# Status of the TRUPACT-III Application

Western Governor's Association  
WIPP Transportation Advisory Group  
May 5, 2005

Earl Easton  
Spent Fuel Project Office  
U.S. Nuclear Regulatory Commission

# Closure Lid Flange Area

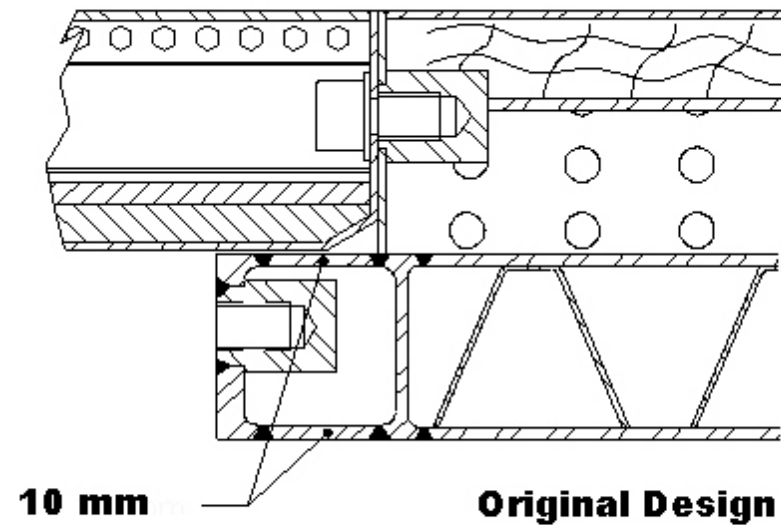
## Concern No. 1 : Non-linear analysis showed yielding in the seal region.

- Thicken inner and outer body flange by 50%.
  - Thicken outer flange plate by 25%.
  - Extend bolting bosses through body flange.
  - Added “dogleg” to radial rib.
- 
- Conduct full-scale impact test and demonstrate leak tightness.

Added Dogleg

Extended Bolt Boss

# Wall Cross Section

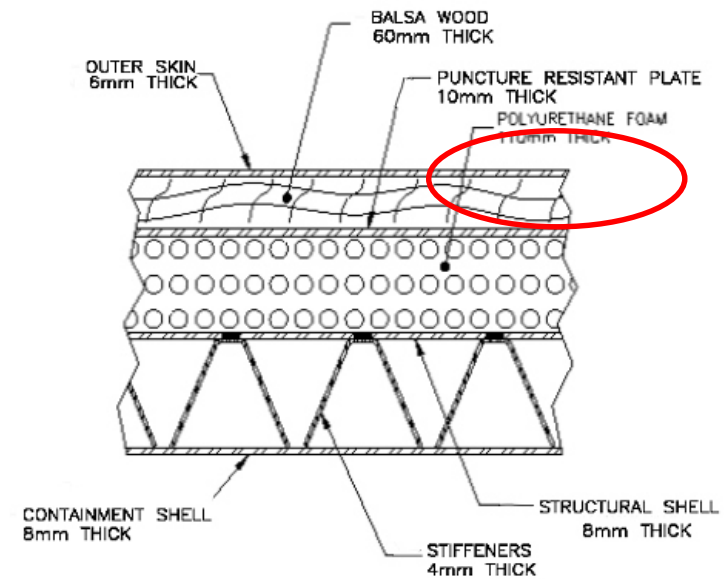
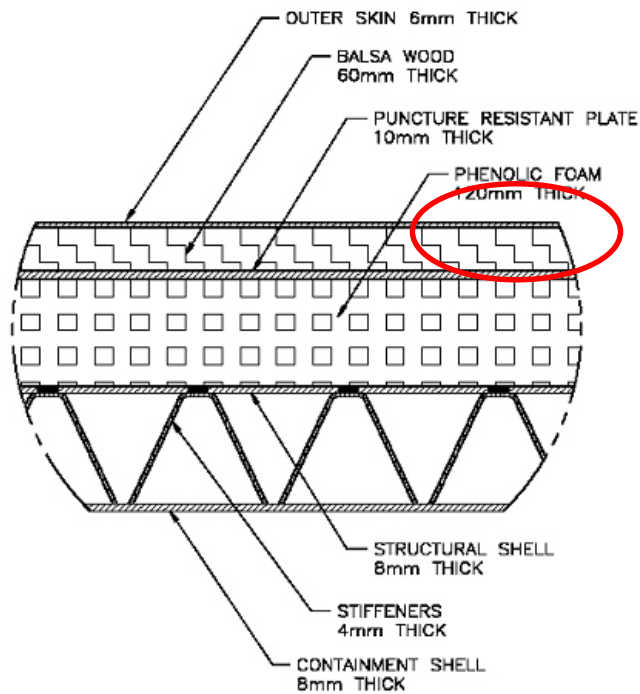
Concern No. 2 : Margins were too small  
given variability of impact limit strength.

- Strengthened Flanges
- Improved properties of impact absorbing materials (e.g., foam)

Foam changed to enhance impact strength.
